Monks Orchard Residents' Association Planning

14th July 2023

Reference: **23/01405/FUL**
 Application Received: Mon 10 Apr 2023
 Application Validated: Tue 26 June 2023
 Address: **6 Orchard Rise Croydon CR0 7QY**
 Proposal: **Host dwelling:** Erection of two-storey side return extension, first floor side/rear extension, first floor terrace and second floor side/rear terrace extension with associated works. Alterations to fenestrations;
Garden subdivision: Erection of two-storey four-bedroom detached house on land to the rear of No. 6 Orchard Rise, including top floor roof terrace, new vehicular access and crossover from Oakview Grove, car parking and all associated site works.
 Status: Awaiting decision
 Case Officer: Samuel Wong
 Consultation deadline: 21st July 2023

Please accept the following **MORA** assessment of the proposed Planning Application **Reference: 23/01405/FUL** for **6 Orchard Rise Croydon CR0 7QY**.

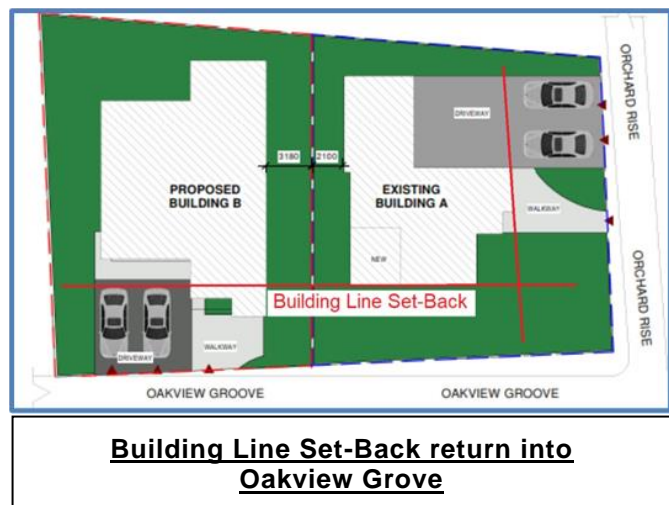
- 1.5.1.2 The proposed **Building A** is **≈8.75m** high whereas the new proposed development **Building B** is **≈10m** in height and therefore clearly a **14.29% increase**. **Therefore, Building B is NOT 'subservient' to the existing Host Building A.**

1.5.1.3 The proposed **Building B** significantly **fails** to comply with **Policy DM10.1** regarding 'subservience' and should therefore be **refused**.

Graphical illustration of Proposal’s Residential Densities and the required supporting PTALs as appropriate for the Area Type Settings.

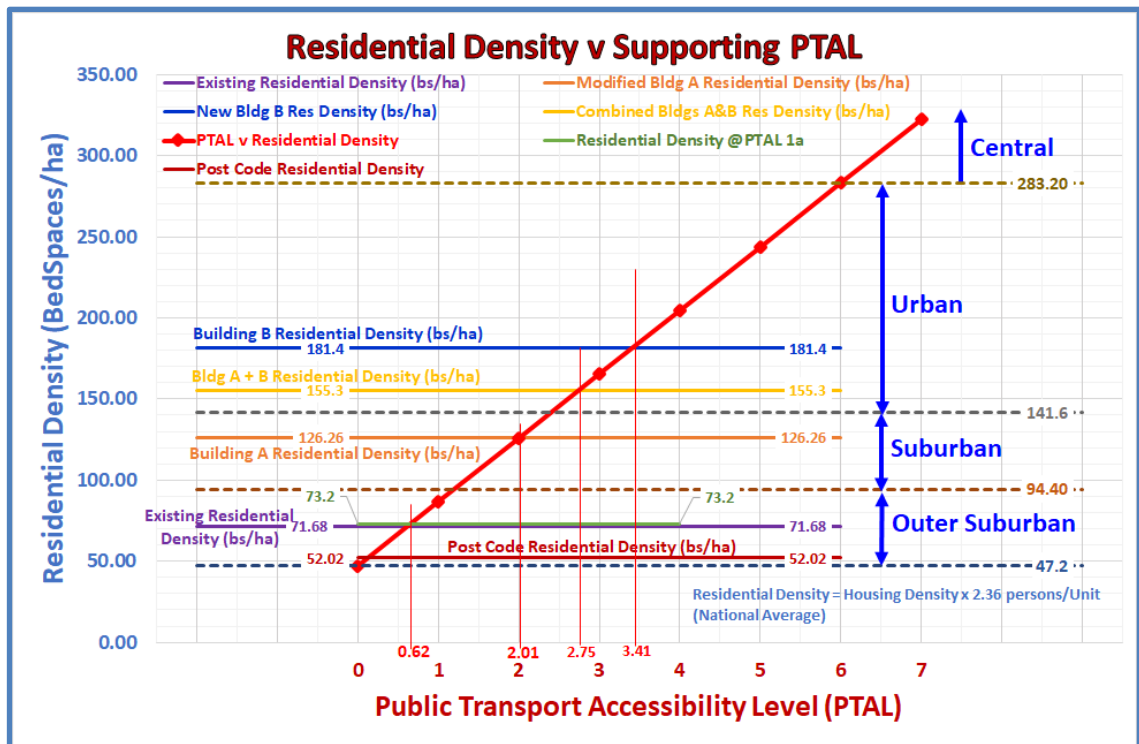
2.6.3 The Local **Area Type** Setting is **Outer Suburban** and the **Residential Density** of **73.2 bs/ha** would be appropriate for a **PTAL 1a** \equiv **0.66**.

2.6.4 This assessment of **Public Transport Accessibility** clearly demonstrates the overdevelopment of the proposal in terms of **Residential Densities** inappropriate for the locality defined by the **Design Code** on the evaluation based upon the guidance provided in the **National Model Design Code & Guidance (2021)** as published by the **Department for Levelling Up, Communities & Housing (DLUCH)** and referenced from **para 129 of the NPPF (2021)**.

Google Earth image of Oakview Grove showing width of access road and footpath (One Side only)

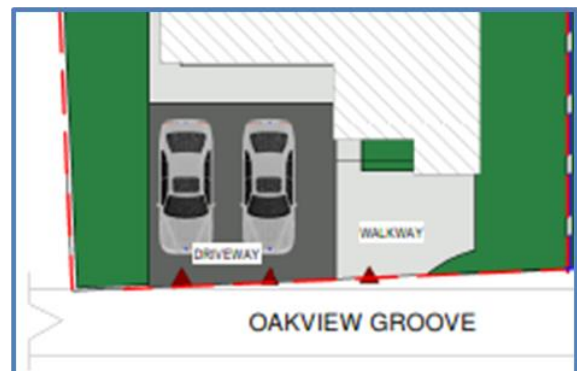
- 5.1 Most passenger cars have a turning curve of **≈5.3m** inner radius and an outer radius of **≈12.5m**. Therefore, to access the drive of the New **Building B** would require more than a single attempt at access.
- 5.2 It would probably require an initial attempt, a reversal and re-attempt to gain satisfactory access.

- 5.3 Swept path diagrams should definitely be provided to show the required number of attempts to gain ingress or egress, for each bay with the other Bay occupied. (The misspelt “Grove” is a copy of the applicant’s document). This would be further restricted by the existing mature ‘**Street Tree**’ directly in the path of the access to the parking Bays for **Building B**. This **Street Tree** would need to be removed and a new **crossover provided**, and a **replacement tree** positioned some distance away.
- 5.4 **Oakview Grove** road width is $\approx 3.7\text{m}$ as measured on Google Earth and the footpath (one Side only) facing the proposed Building B is approximately $\approx 1.8\text{m}$ width. The Width at **3.7m** is the minimum width allowable for Emergency vehicles and Fire Tenders.
